UNITED STATES PATENT AND TRADEMARK OFFICE

10/616,872

Office Action Summary	Application No.	Applicant(s)	
	10/616,872	THOMAS ET AL.	
	Examiner	Art Unit	
	Ghassem Alie	3724

DETAILED ACTION

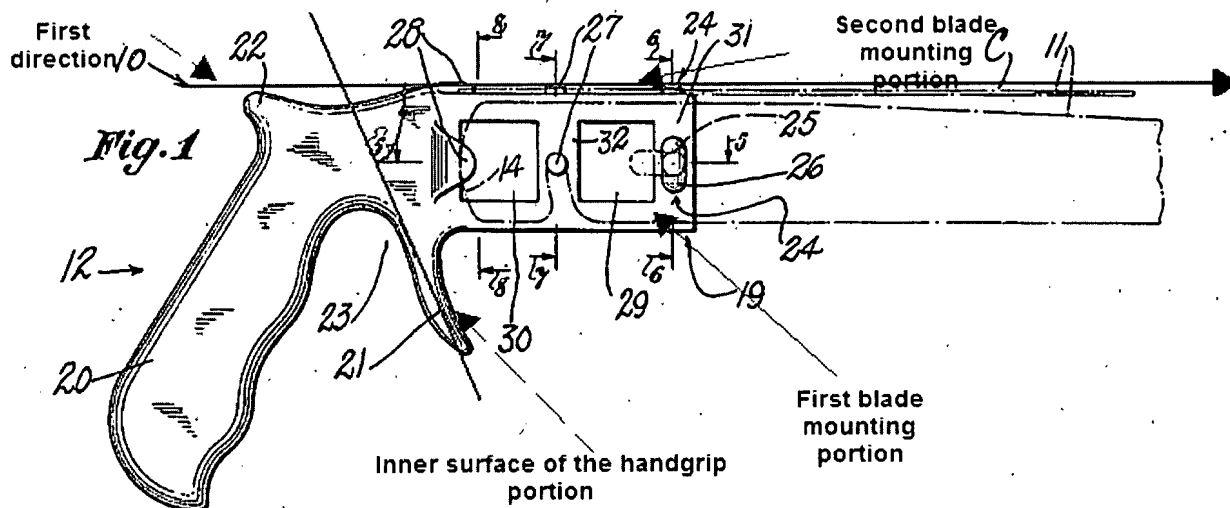
3. Claim 3, 6, and 23 are rejected under 35 U.S.C. 102(b) as being anticipated by Davey (2,017,895). Regarding claim 23, Davey teaches a hand saw 10 including a handle 12 having a handgrip portion 21 defining an inner surface 21A. It should be noted that handle 12 includes two portions 20, 21 that could be gripped by a user's hand. In this case, the second

portion 21 of the handle 12 is considered to be a handgrip portion, since it is gripped by a user's hand. Davey also teaches that the saw includes first and second blade mounting portions 24, 27. It should be noted that the T-headed stud 24 and the pin 27 at A or B defines the first mounting portion. The second mounting portion is defined by the T-headed stud 24 and the pin 27 at C. Davey also teaches that the first mounting portion being disposed on a side surface of the handle 12 and the second blade mounting portion being on a bottom surface of the handle 12. Davey also teaches a blade A-C removably mounted to one of the first and second blade mounting portions and extending away from the handle 12 in a first direction. Davey also teaches that the handgrip portion is sloped toward the blade so as to be oriented at an acute angle relative to the second blade mounting portion. It should be noted that the inner surface of the handgrip portion 21 is sloped toward the blade as the inner surface of the handgrip portion in the instant application. Davey also teaches that the first and second blade mounting portions each include a key 27 adapted to be received in an end slot in the blade.

7. Applicant's arguments filed on 05/11/07 have been considered but they are not persuasive. Applicant's argument that Davey fails to teach that the angle of the inner surface of the handgrip relative to the second blade mounting portion is an acute angle is not persuasive. As stated above, Davey teaches that the handgrip portion is sloped toward the blade so as to be oriented at an acute angle relative to the second blade mounting portion. It

should be noted that the inner surface of the handgrip portion 21 is sloped toward the blade as the inner surface of the handgrip portion in the instant application. See Fig. 1 above.
